Lot 71 🗸

Model Arabian (42-7) Elev B

INVENTORY LOT 71

Colours Upgrade Report
Kings Ridge Print Date: 20-Mar-13

ARABIAN

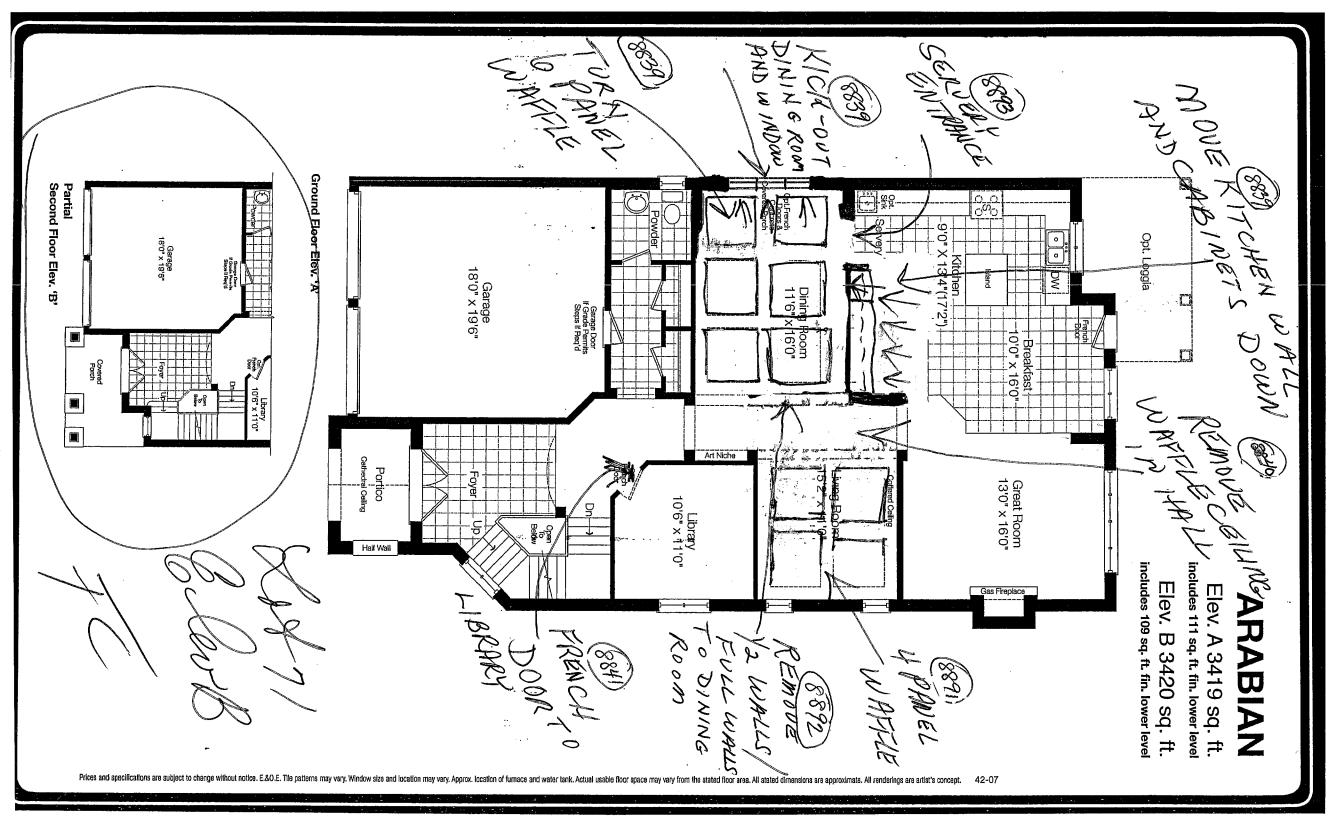
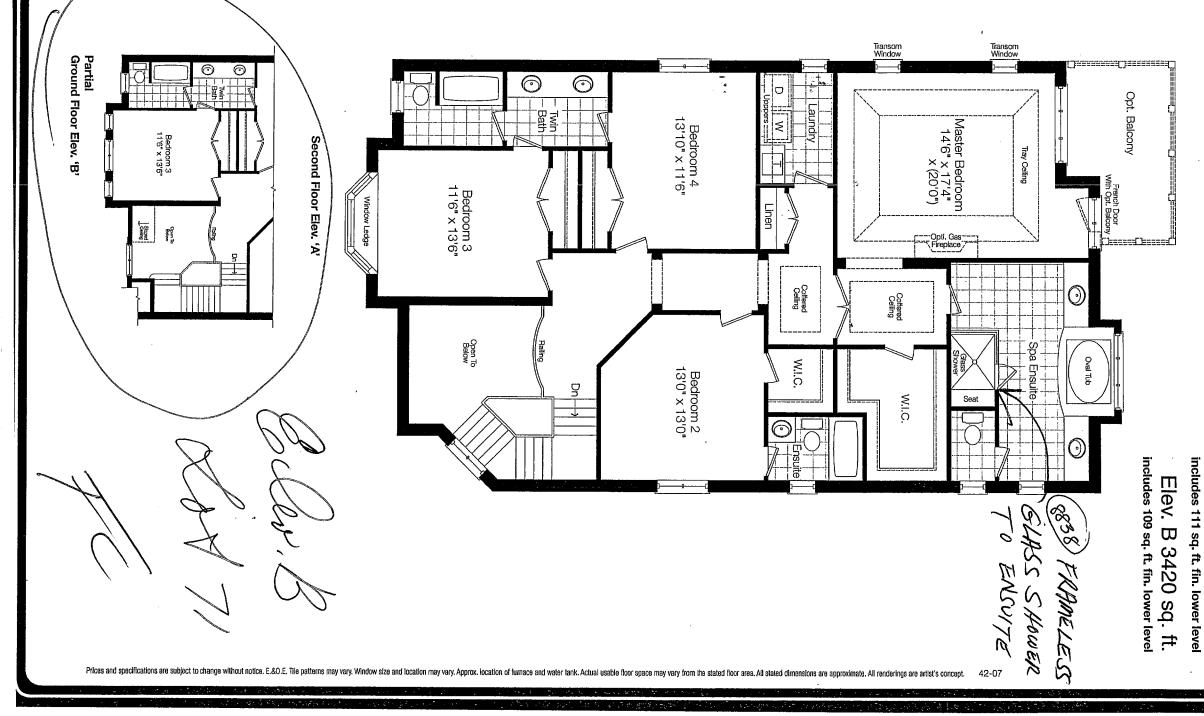
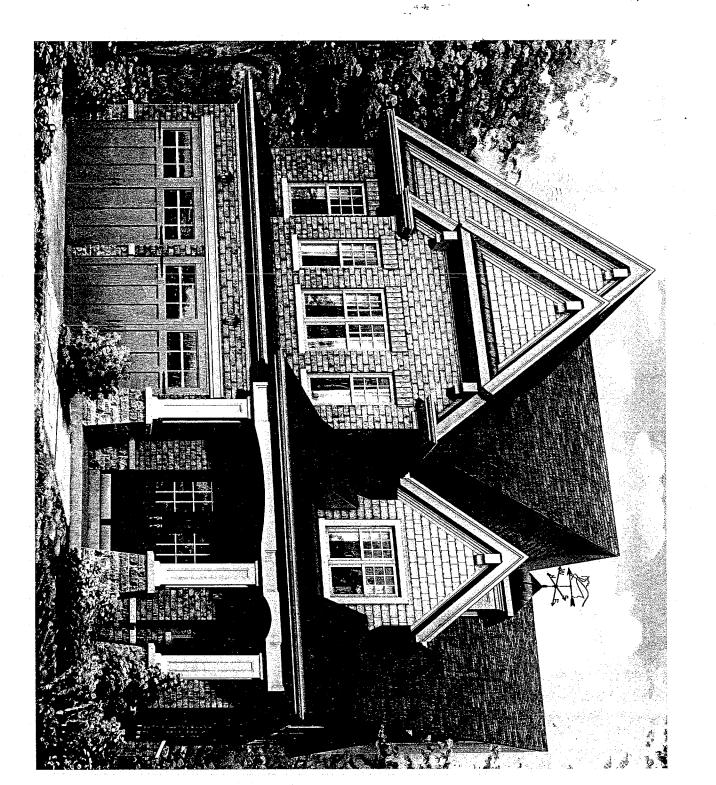
| | ID | Group | Description | Invoice | Date Ordered | |
|---|------|-------------------|--|---------|-----------------|--|
| | 8836 | INCLUDED IN OFFER | Walk out basement with 5ft x 7ft deck off rear of house (no stairs) | 1712 | | |
| L | 8837 | STRUCTURAL | BASEMENT WINDOWS - larger basement windows (3) 24 x 30 | 1712 | | |
| L | 8838 | STRUCTURAL | Frameless glass shower to master ensuite | 1712 | | |
| ı | 8839 | STRUCTURAL | Make basement wall straight (kick out). Kick out dining room with window and turn coffered ceiling. Move kitchen down into dining room with same standard cabinets | 1712 | | |
| 1 | 8840 | STRUCTURAL | MAIN FLOOR HALL - remove waffle ceiling | 1712 | | |
| L | 8841 | STRUCTURAL | LIBRARY - install french door | 1712 | | |
| L | 8842 | STRUCTURAL | PLUMBING - water line to fridge | 1712 | | |
| | 8843 | STRUCTURAL | HVAC - rough in gas line to stove | 1712 | | |
| | 8891 | STRUCTURAL | LIVING ROOM Change waffle ceiling to 4 panels in living room | 1712 | | |
| | 8892 | STRUCTURAL | DINING ROOM Remove wall and half walls to dining room off of main hallway | 1712 | | |
| 1 | 8893 | STRUCTURAL | SERVERY Create an opening / servery entrance | 1712 | | |
